Luxmanor Elementary School, Mandatory Referral, MR2018022

Description

RECOMMENDATION

MANDATORY REFERRAL SITE PLAN

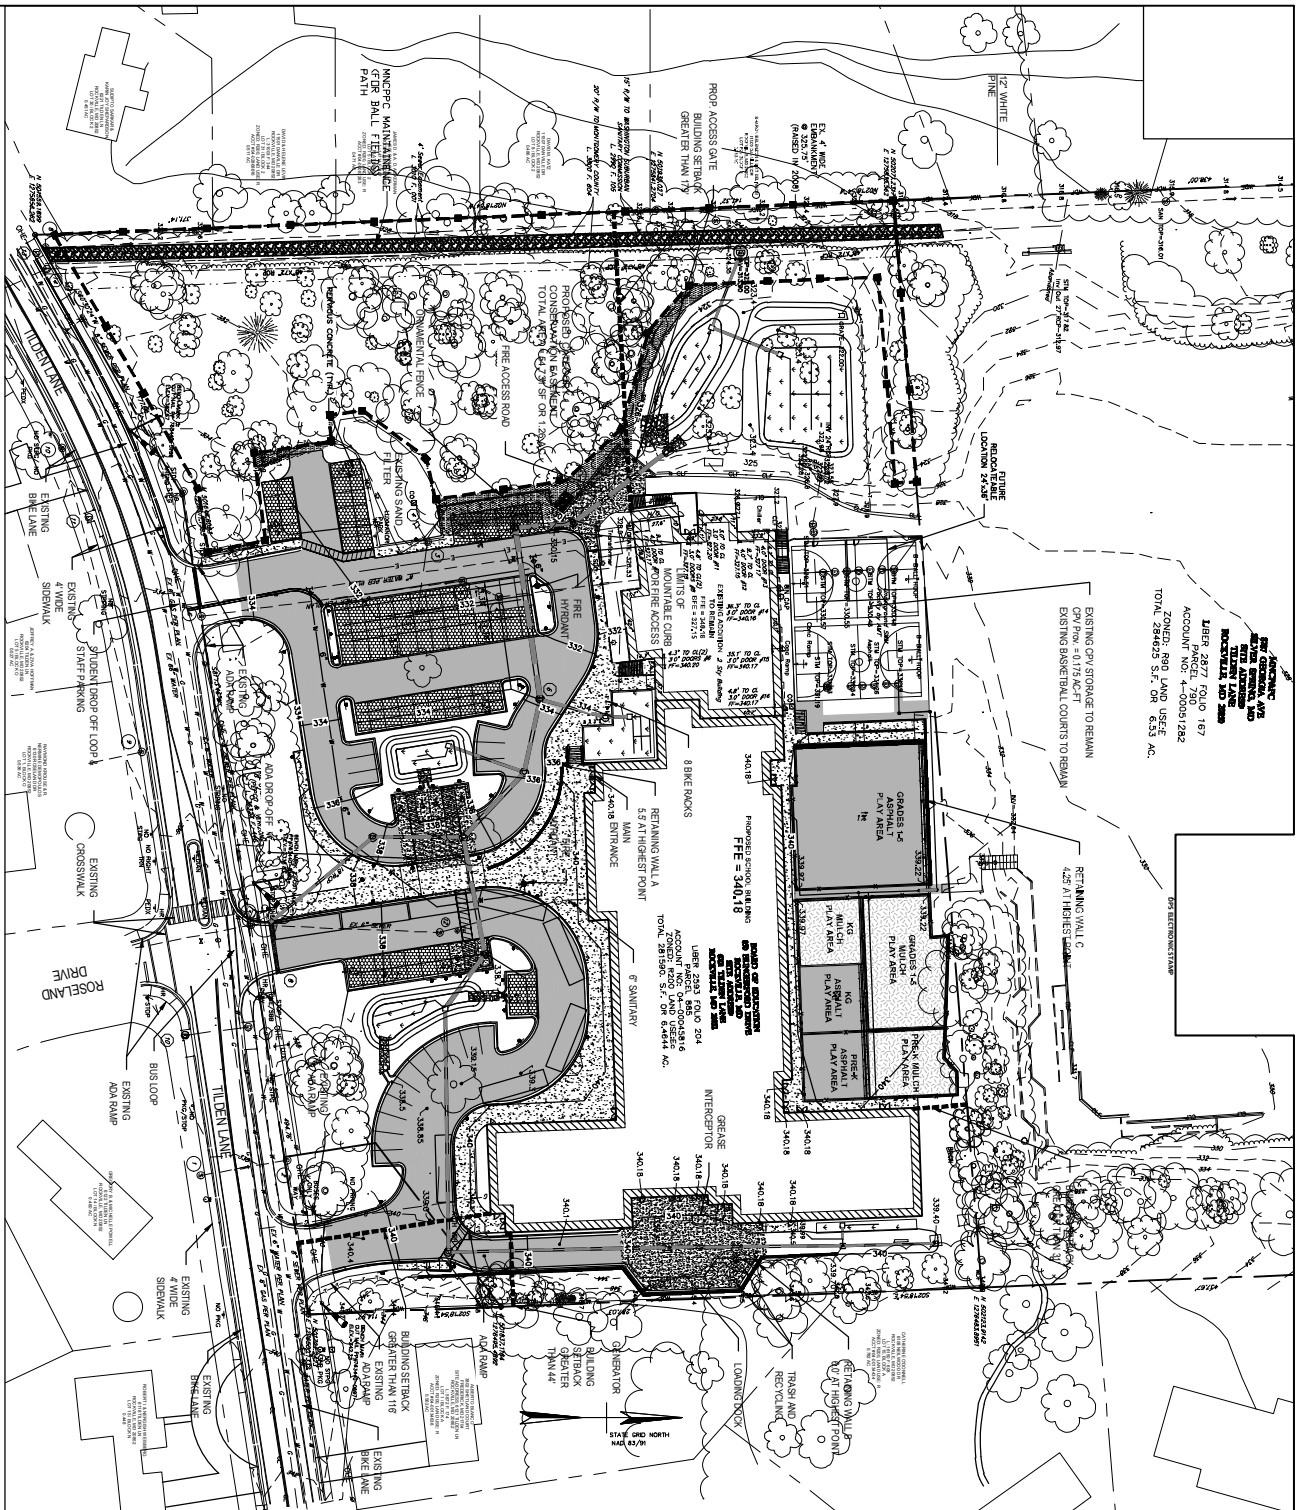
4. MCPS should upgrade the substandard sidewalk along school frontage of Tilden Lane, a residential primary street, in accordance with Road Code Standard #2003.09 to have at least a 5-foot-wide sidewalk and a tree panel between the sidewalk and curb. MCPS should work with Montgomery County Department of Transportation (MCDOT) for the specific road cross-sectional elements.

MCPS should upgrade the substandard sidewalk along school frontage of Tilden Lane, a residential primary street, in accordance with Road Code Standard MC-2003.09, to have at least a 5-foot-wide

sidewalk and a tree panel between the sidewalk and curb. MCPS should work with MCDOT for the specific road cross-sectional elements. In addition, MCPS should work with MCDOT regarding their Pedestrian Safety Initiative to improve the nearby off-site sidewalks.

- Upgrade the lead-in sidewalks from Tilden Lane and internal pedestrian connections, but not along the Tilden Lane frontage.
- Provide four bike racks at the northern end of the parent drop-off/pick-up loop. Additional bike racks are recommended near the recreation fields.

ADA CIRCULATION PLAN

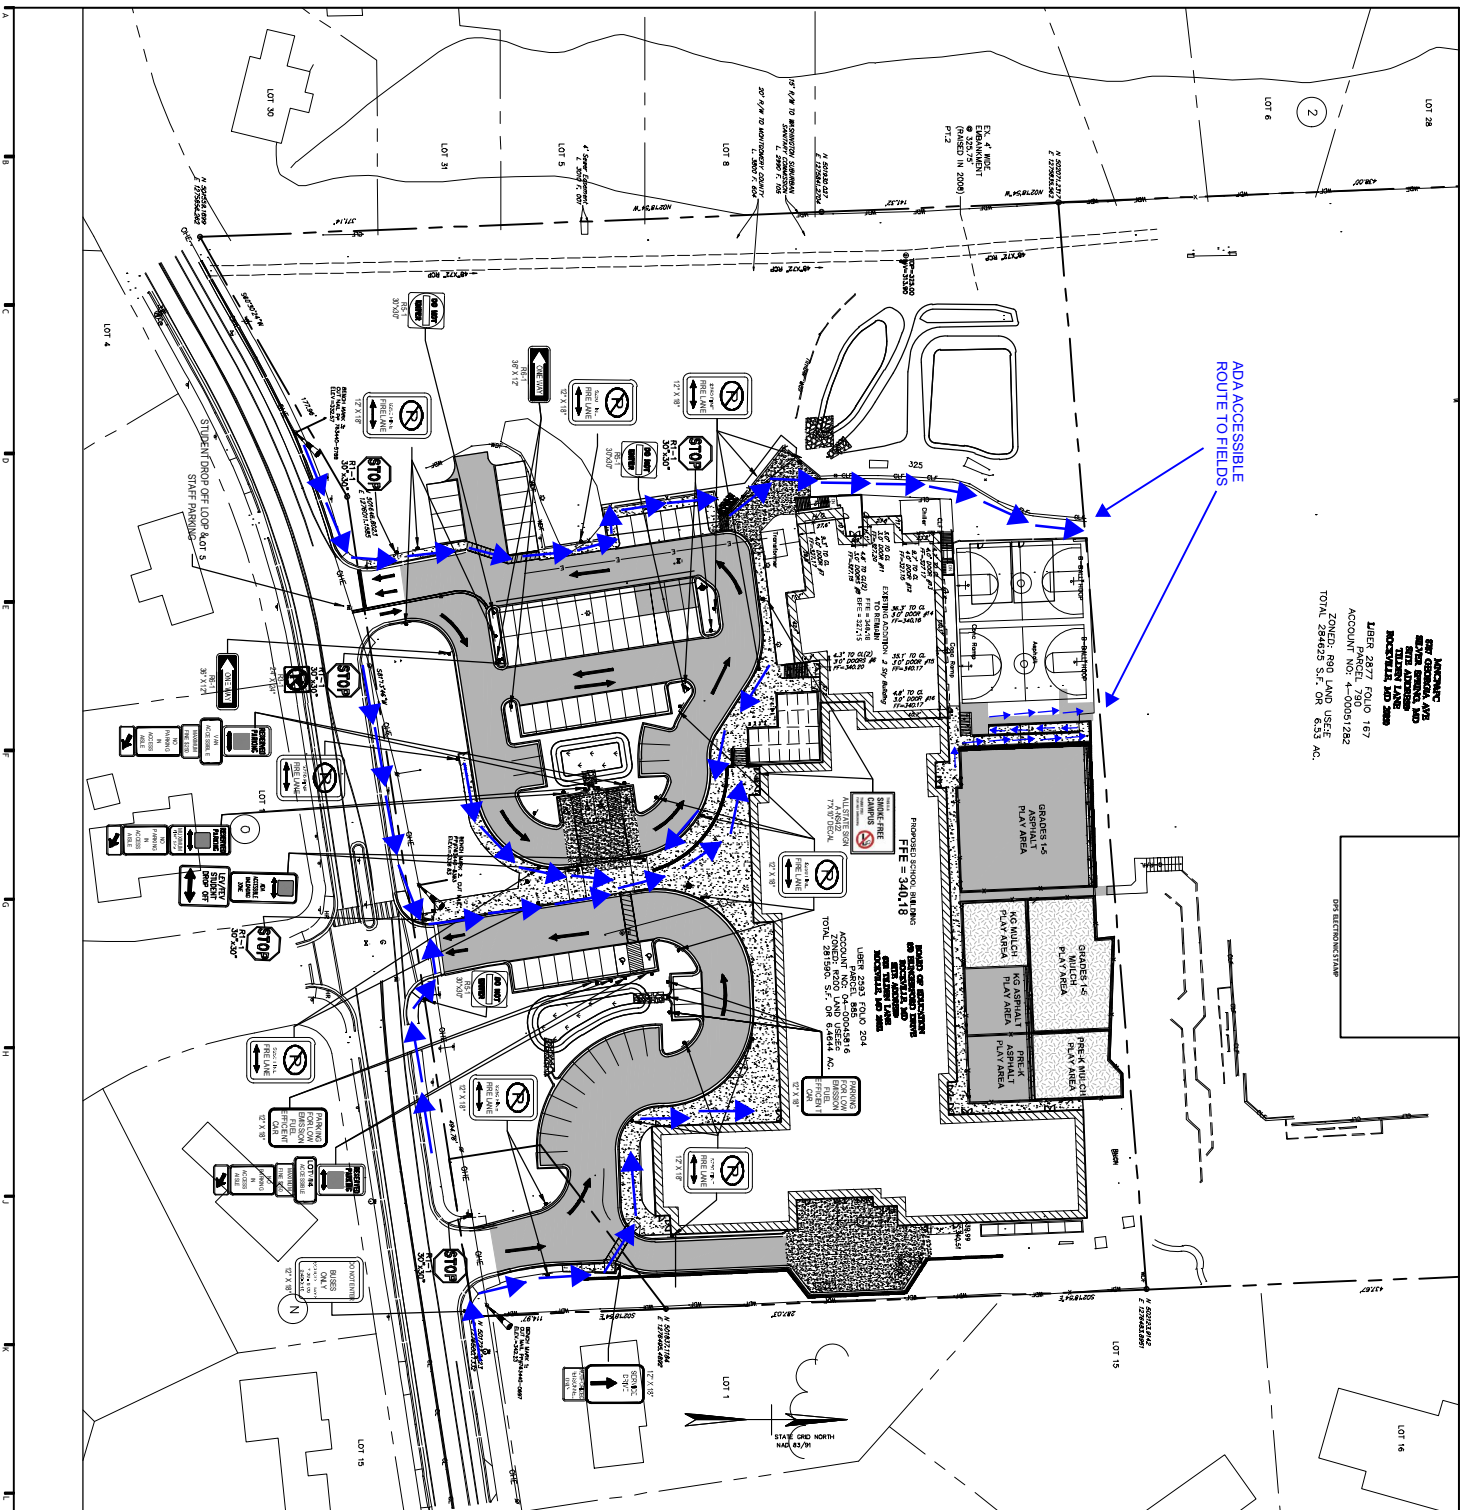
MCPS shall coordinate with M-NCPPC Dept of Parks to provide an exterior ADA compliant walkway as well as appropriate signage from accessible parking spaces to the playing field at Luxmanor Local Park. A walkway shall be constructed to and including a new concrete players bench area for the softball field nearest the school and a wheelchair accessible viewing area for the rectangular overlay. Parks is willing to contribute \$35,000 towards improvements within the Park from the FY19 ADA-Local budget. All ADA work connecting to and in Luxmanor Local Park is subject to M-NCPPC review. All work within park boundaries requires a Park permit and shall be constructed to Park standards.
